Hon. Robert S. Duchesne, Presiding Officer  
Maine Board of Environmental Protection  
17 State House Station  
Augusta, ME 04330

A-14-781-A-N  
L-28319-26-A-N  
L-28319-TG-B-N  
L-28319-4E-C-N  
L-28319-L6-D-N  
L-28319-TW-E-N-N  
W-009200-6F-A-N

RE: Additional comments on the Nitrogen Discharge

Figure 5. Snapshots of plume dilution throughout a typical tidal cycle. high slack (upper left), mid-ebb (upper right), low slack (lower left), mid-flood (lower right).

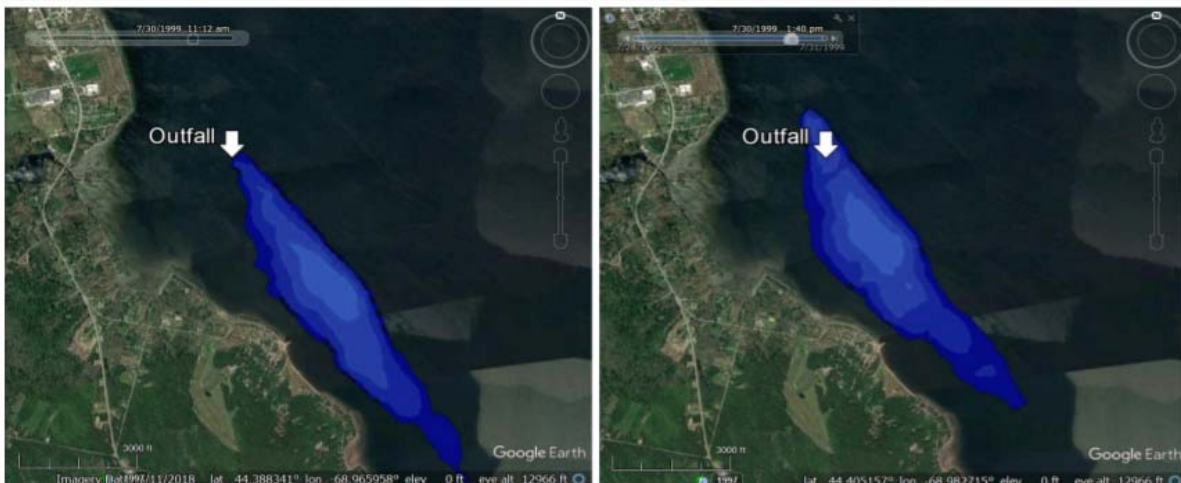
In the second figure above, the plume is now actually “pulling back”, from a dilution perspective, back towards the outfall, as the tide has started to oscillate back in the other direction. This continuous discharge means we would have multiple cycles of minimal dilution oscillating back and forth within our mooring field before it gets anywhere near “open water” discharge.

The Applicant has estimated this cycle, but has no field data to confirm it, and did not run the model long enough to confirm their estimated 14-day averaging period.

The Applicant’s modeling is insufficient to conservatively satisfy the anti-degradation rules and requirements. This dilution factor, combined with background conditions, the lack of desire by the Applicant during testimony to agree to more than 85% removal efficiency, and the new lower limit of 21 mg/L that leaves zero room for assumption or modeling variability, are significant concerns. We believe that these concerns have not been sufficiently addressed by the Applicant.

The Applicant has provided very little nutrient background data for the discharge area and absolutely NONE within the lightest area of the plumes in the two figures, labelled Figure 5 in the Applicant’s materials. While the Applicant and DEP came to some understanding about averaging background conditions for nitrogen for two locations (BB02 and PB03) away from the shore (to supplement the data provided in the original October 2018 application as referenced in the deliberations), these may or may not represent near shore conditions of PB02 or in front of our densely populated areas. The NVC formally requested the memorandums, emails, and back-up material that lead to the changes made by the deliberation memorandum via a FOAA request on more than one occasion, but it was never provided.
